Architectural Review Board Agenda  
4:00 PM Wednesday, July 27, 2022  
Sussex Civic Center – Village Board Room Second Floor

TO: Architectural Review Board  
FROM: Jeremy Smith, Village Administrator  
RE: ARB meeting for July 27, 2022  
DATE: July 18, 2022

### **III. Consideration and possible action on the site, architecture, lighting, landscape and sign plans for Industrial Controls (N56W24842 North Corporate Circle).**

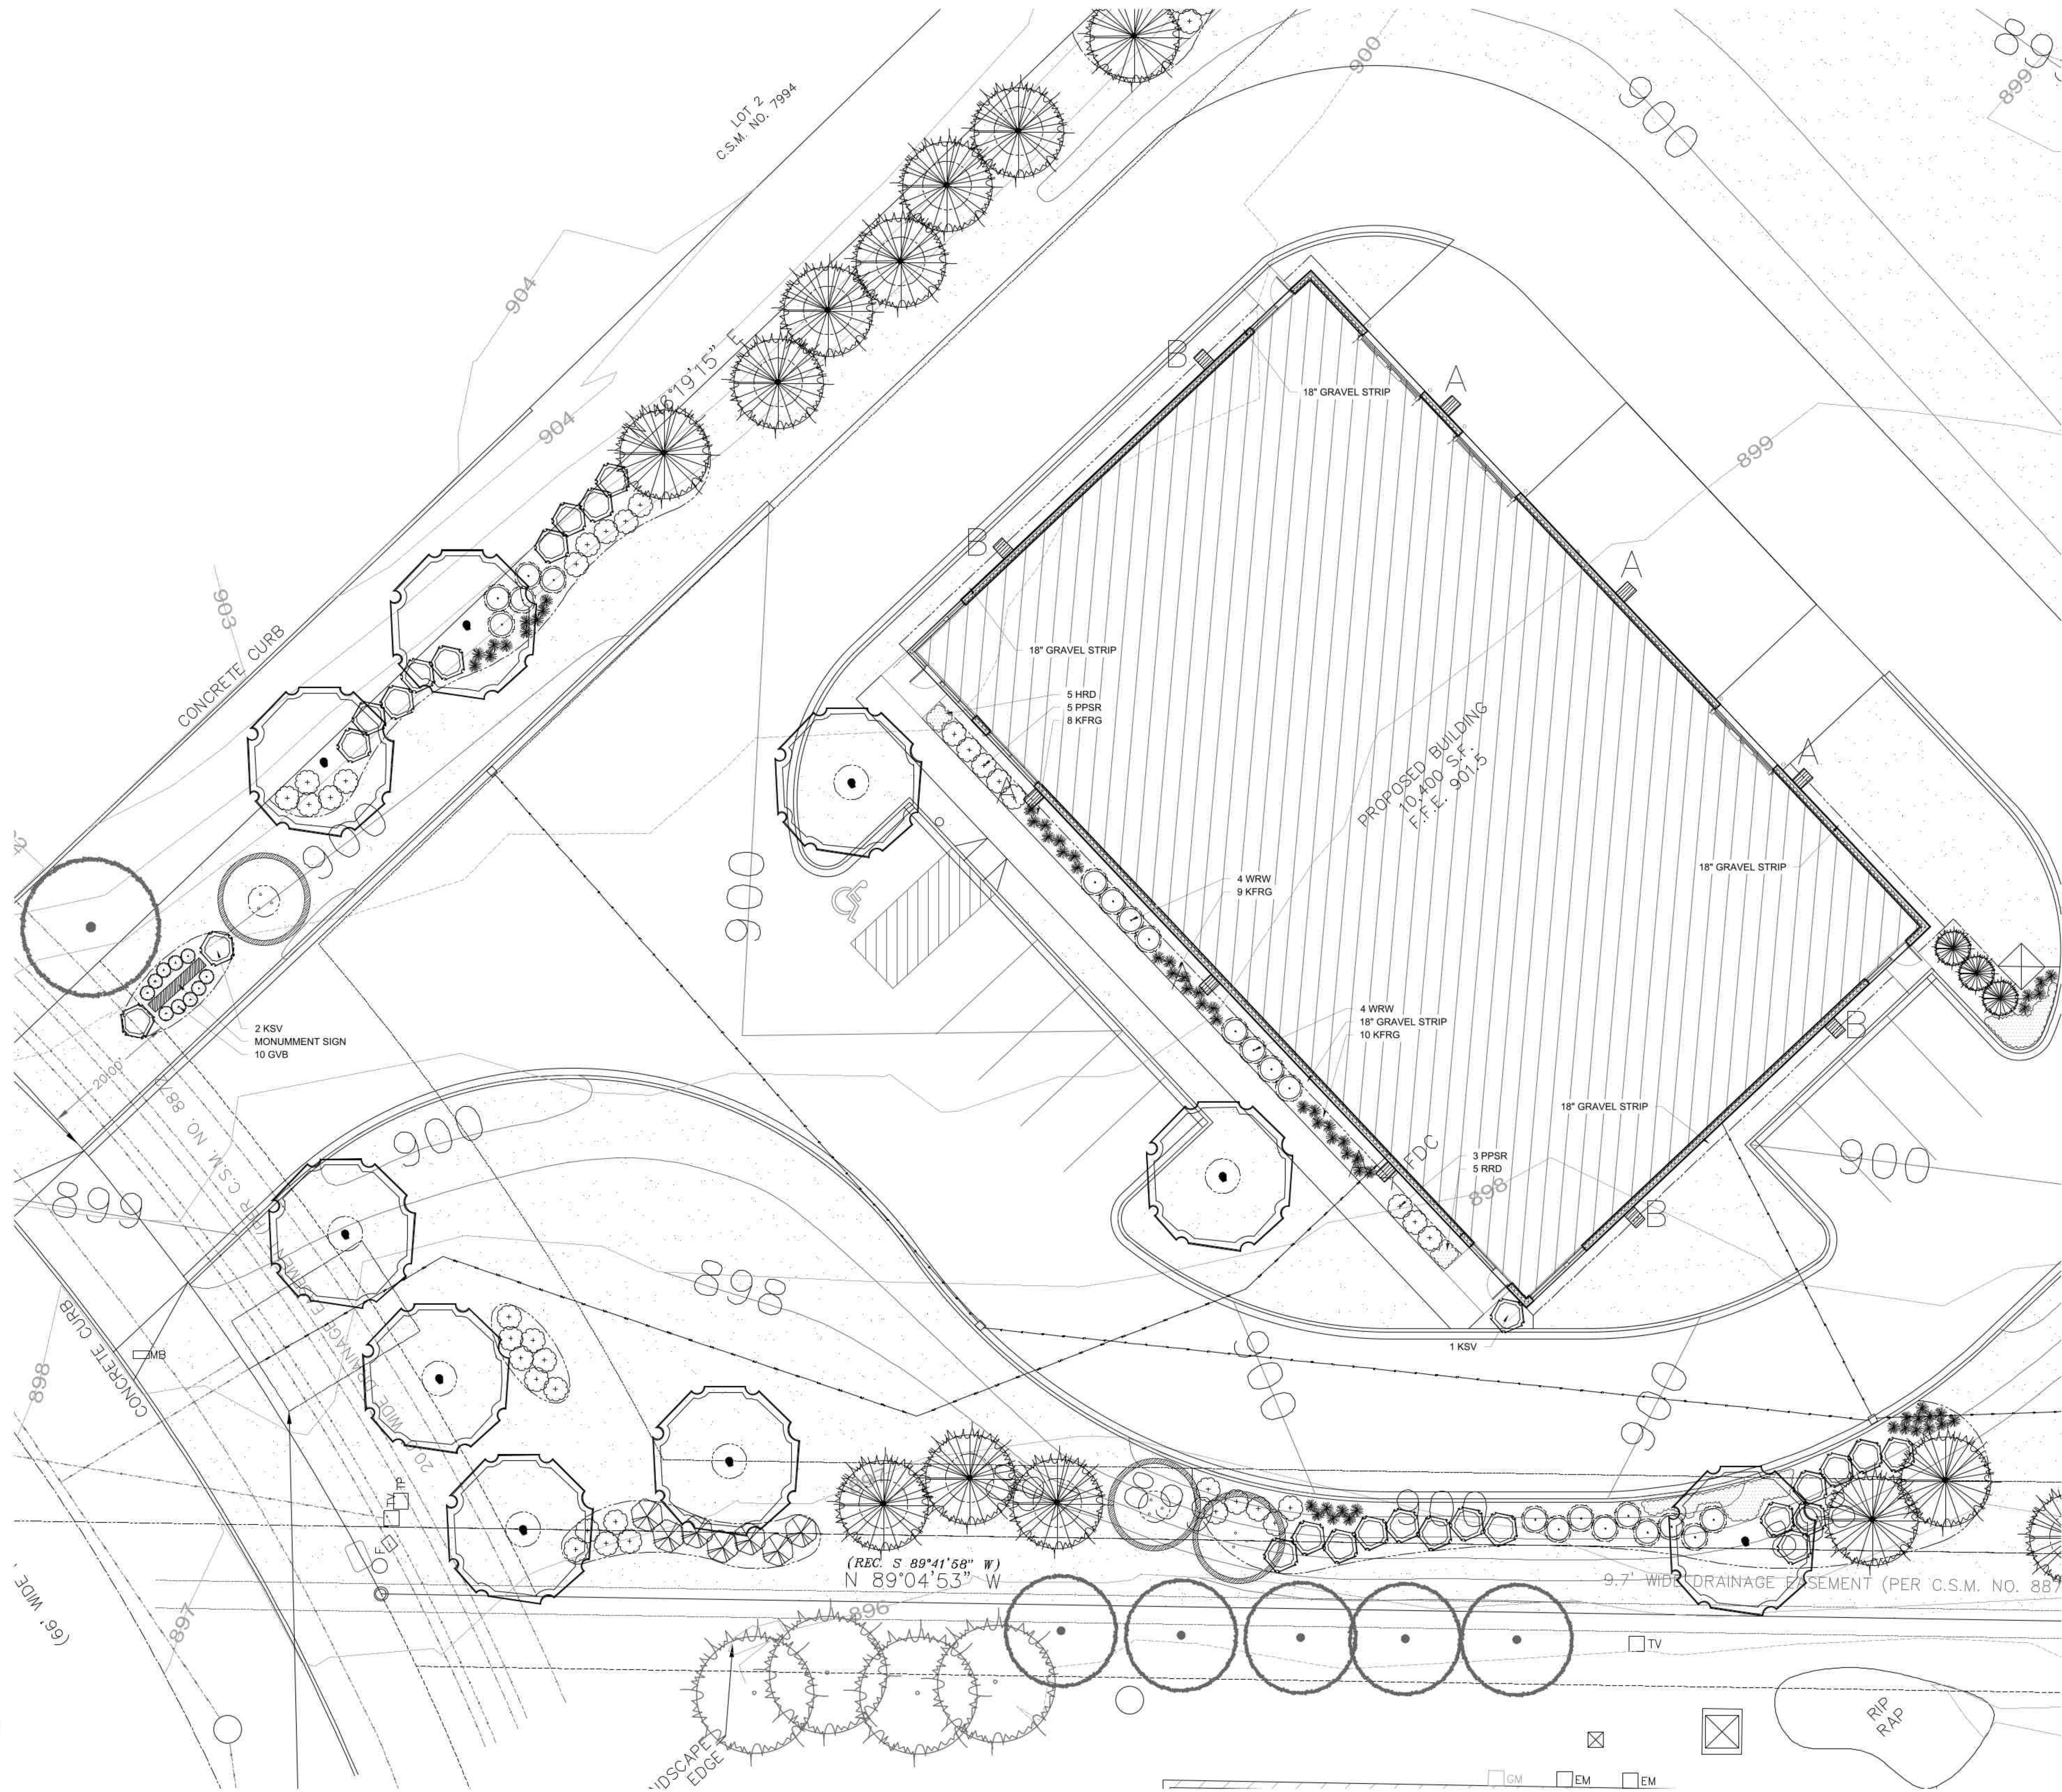
- The landscape plan meets the standards, but some location adjustments are necessary for easements.

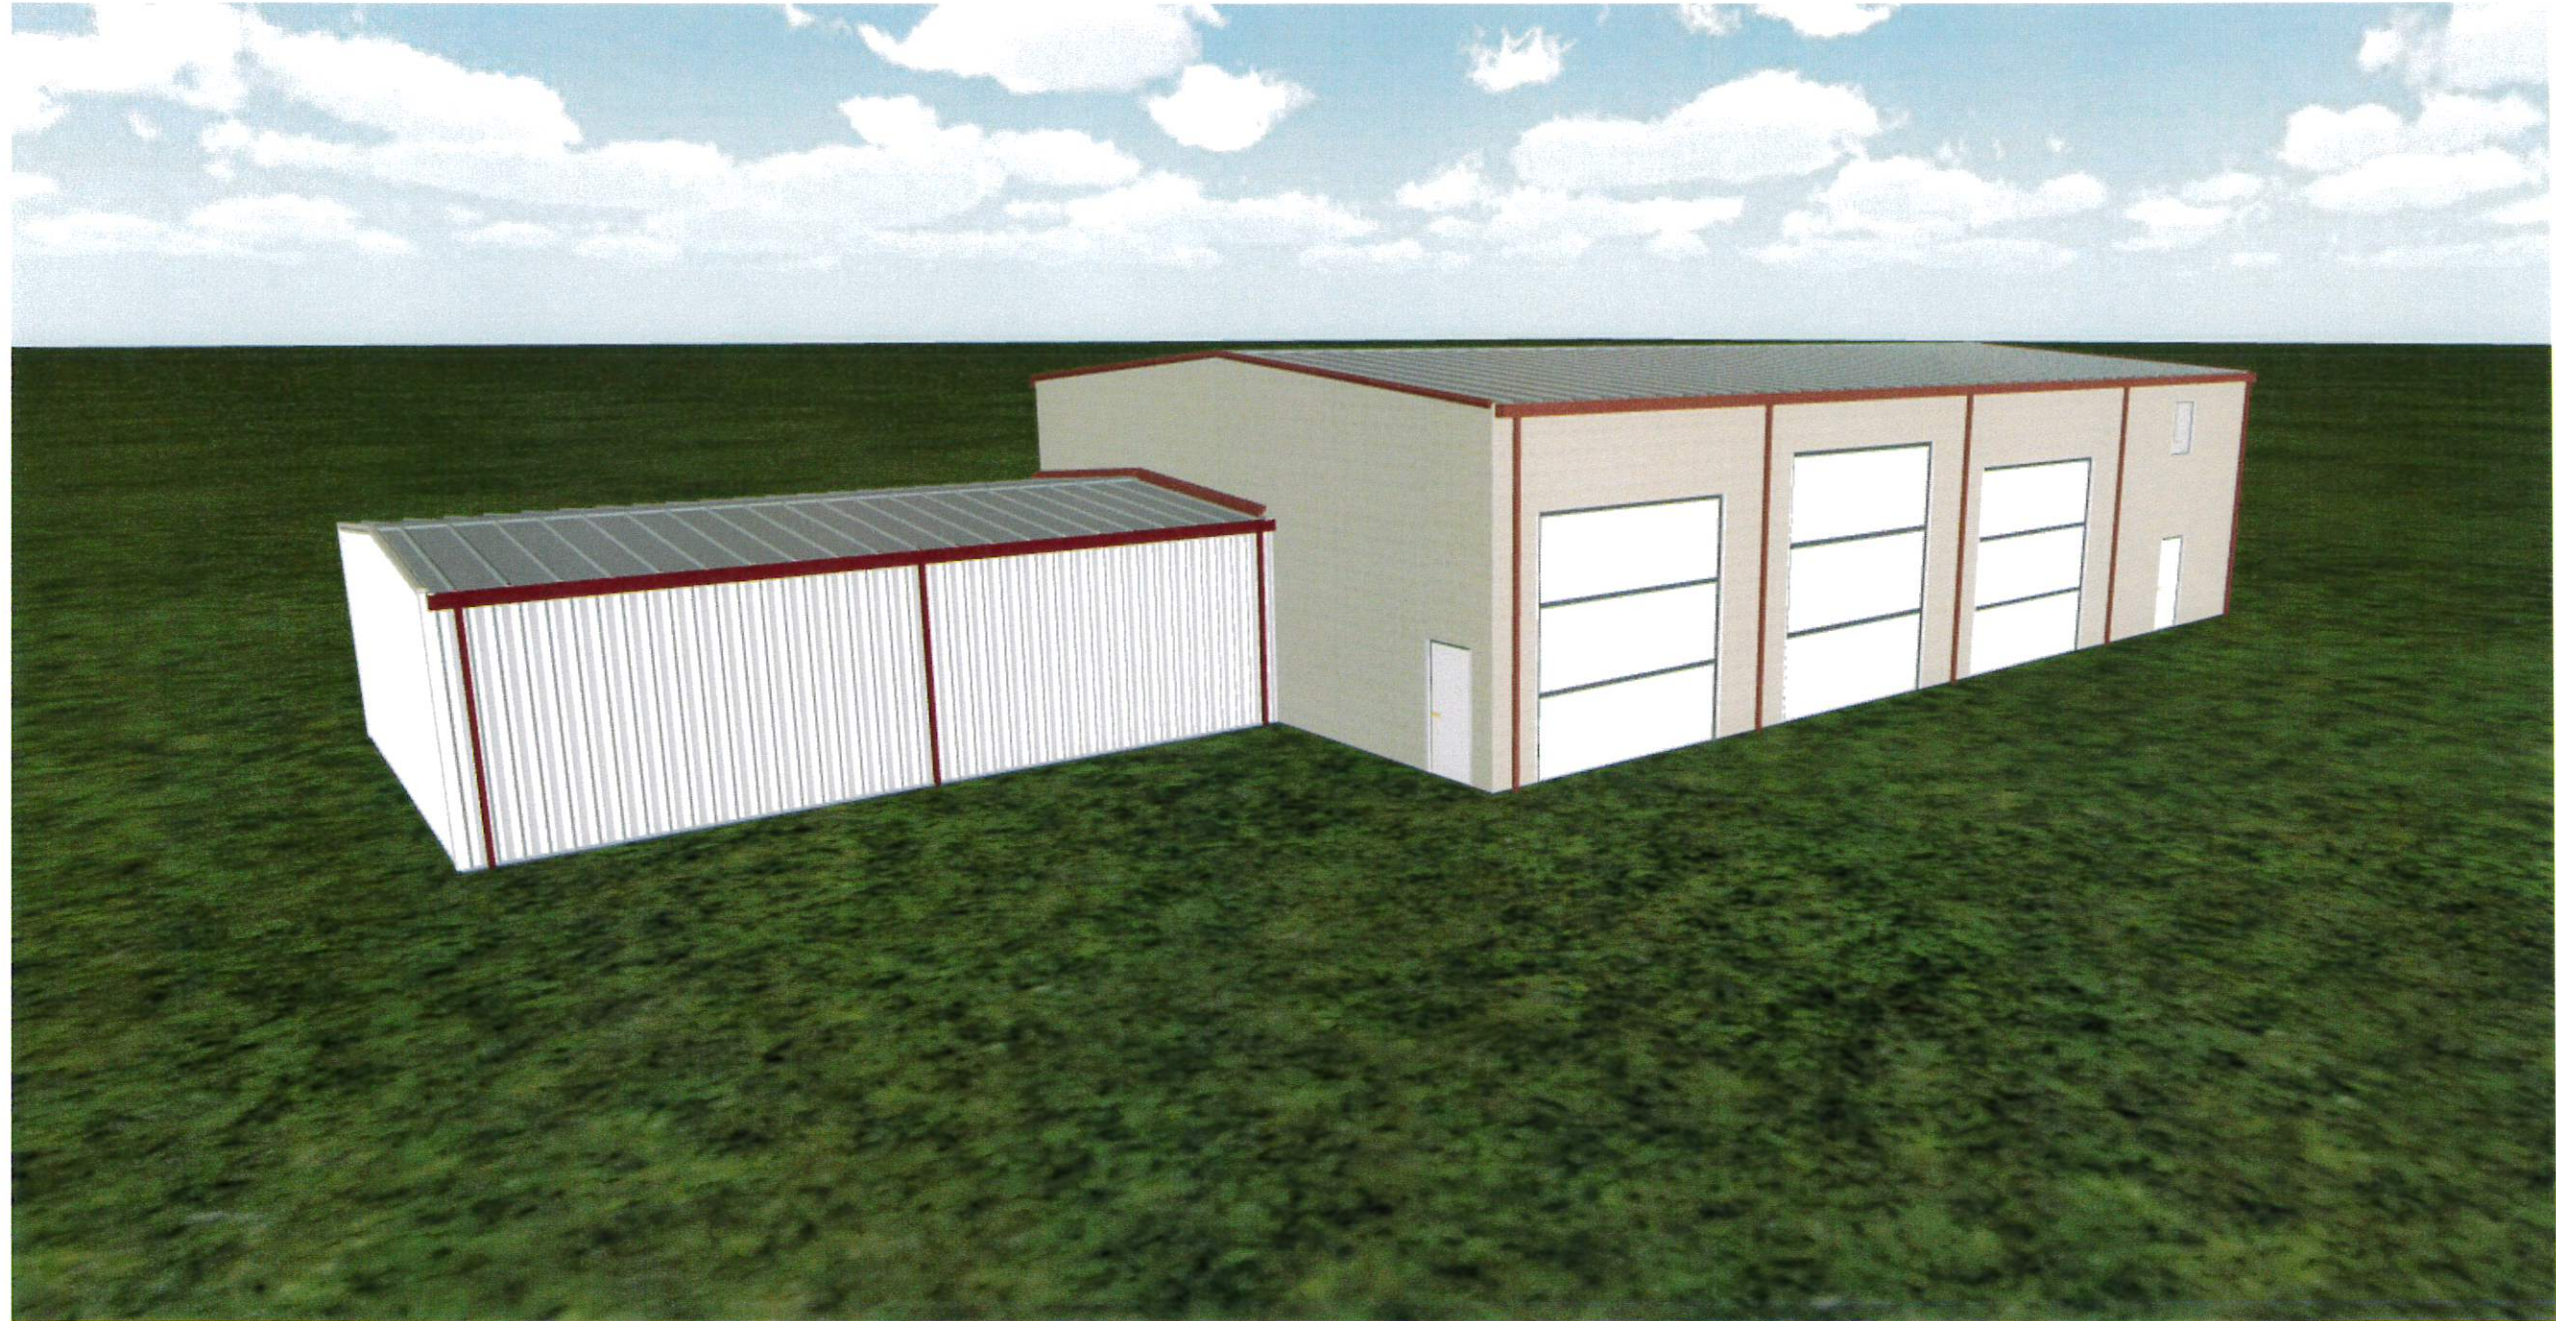
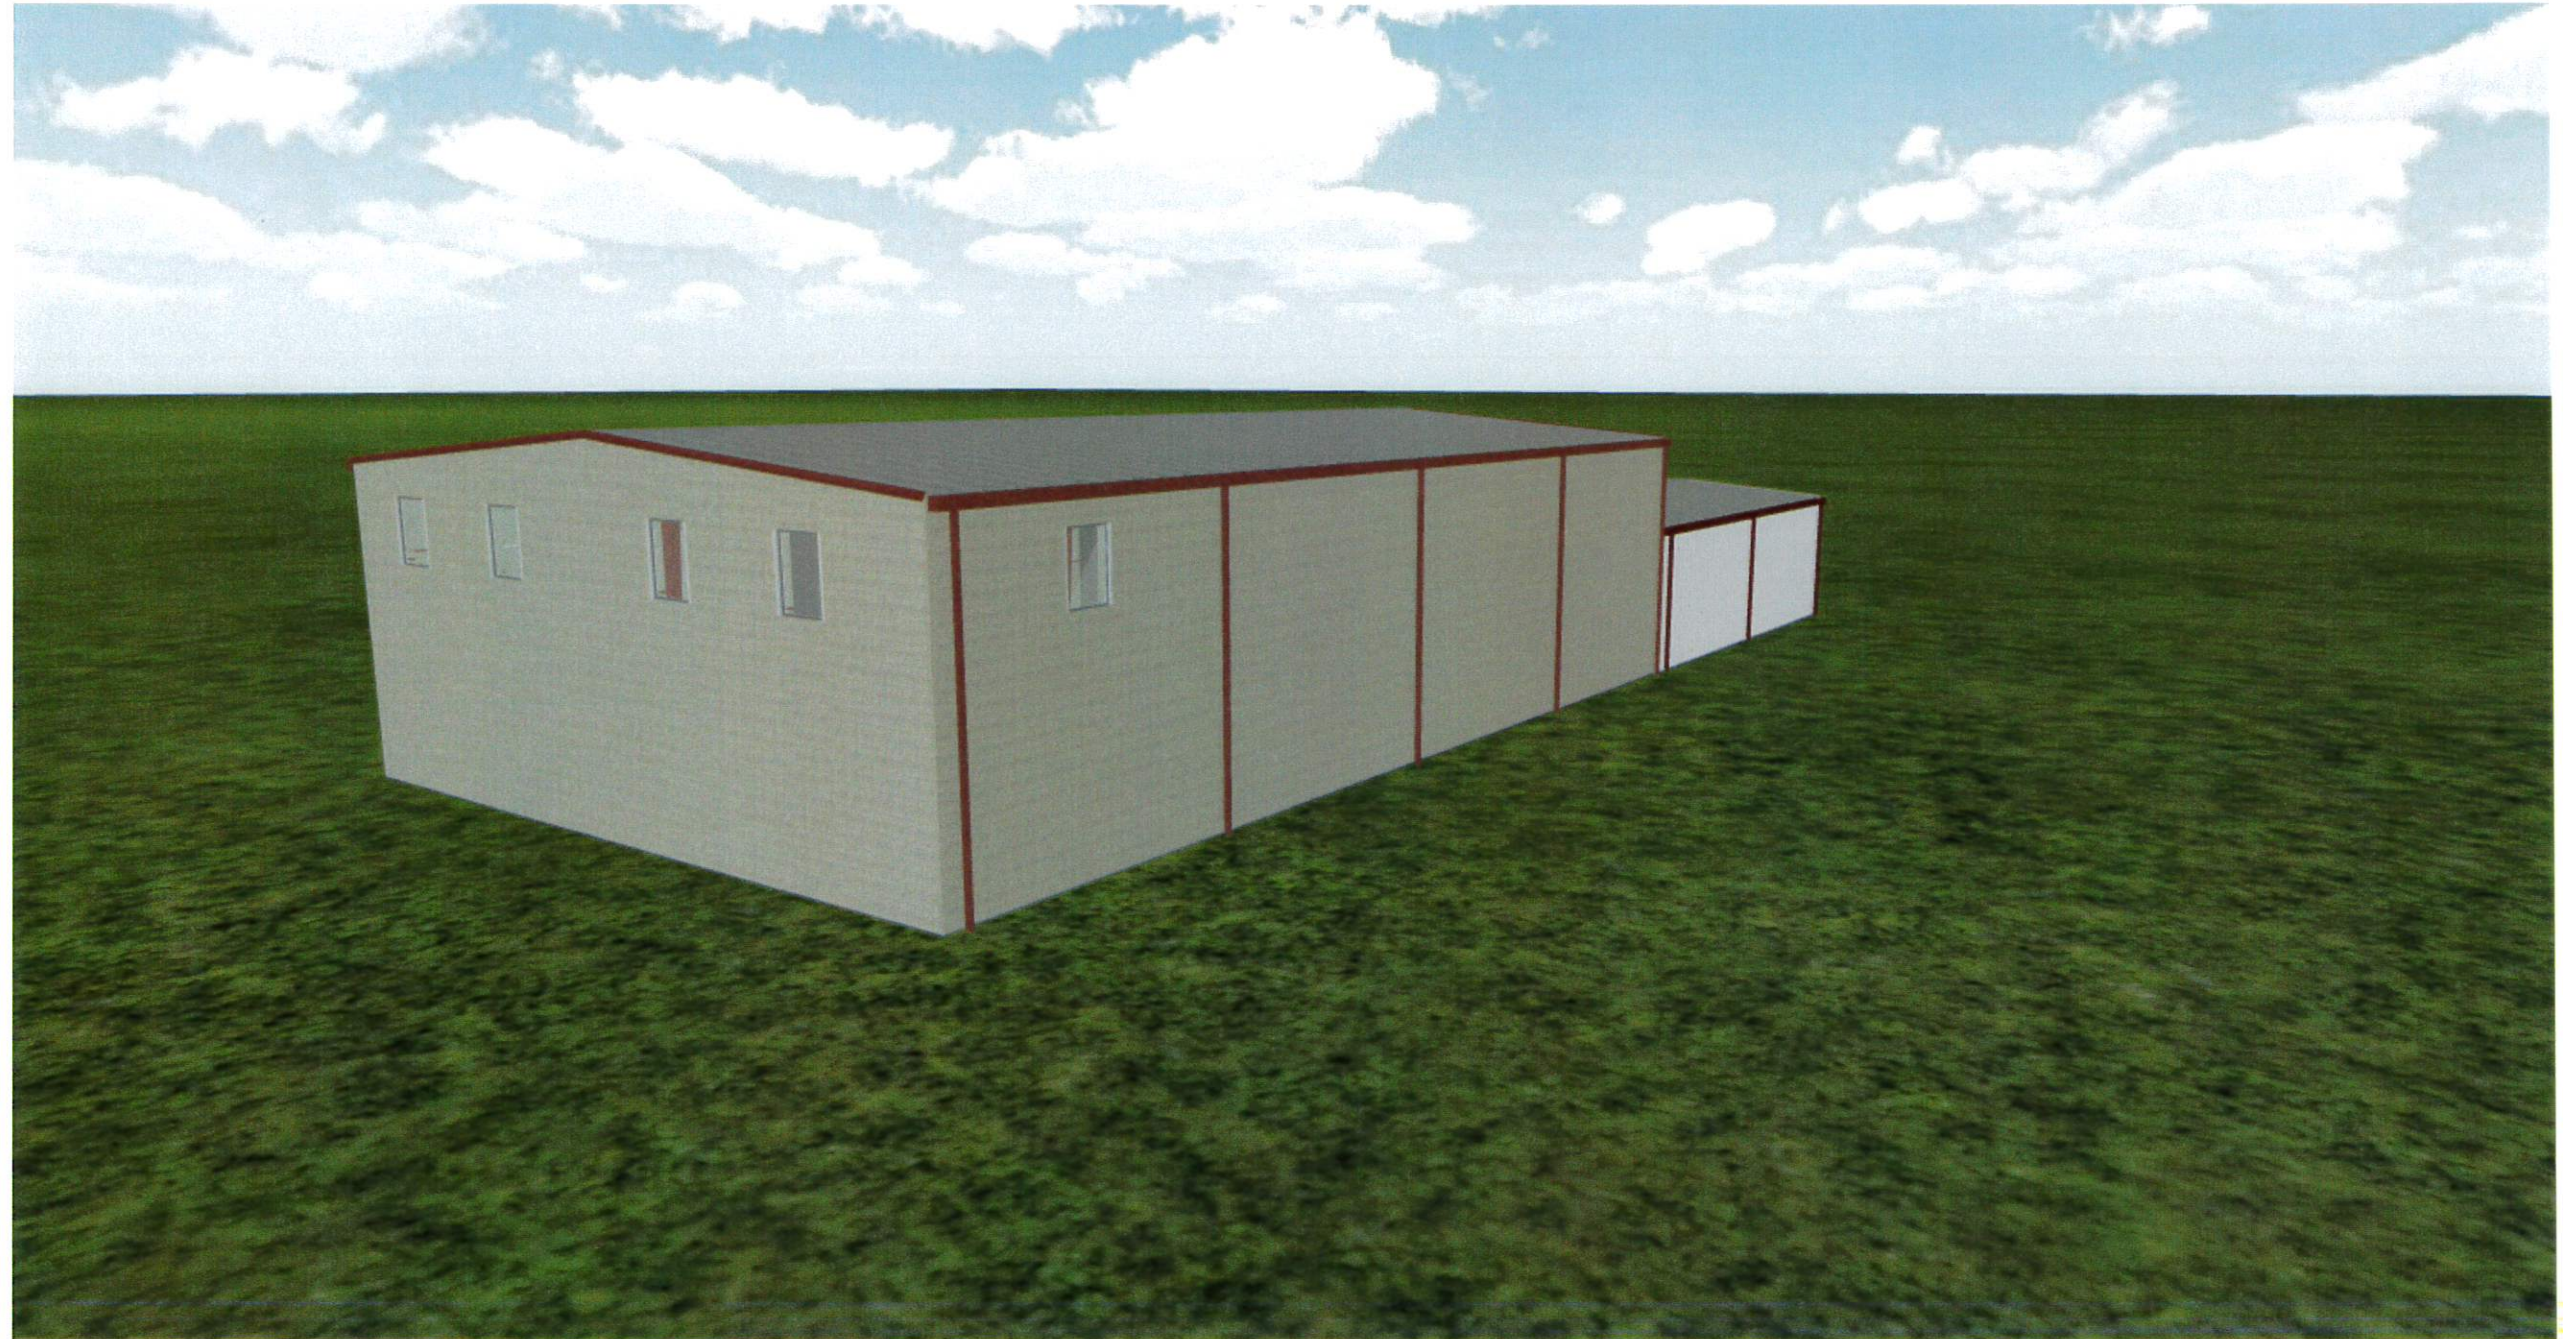
- The Building is to be clad in Lannon stone/cream city brick (Only the upper half of the building will be visible above the fence line.
- 3 windows should be added on the southern elevation
- No additional lighting has been proposed.
- The metal roof should be reviewed by the Board

**Staff Recommendation:** Staff recommends the ARB recommend approval of the architectural plan, for H.M. Brandt subject to the additions of windows per the report, and the metal roof must meet the design standards and any other conditions from the ARB.
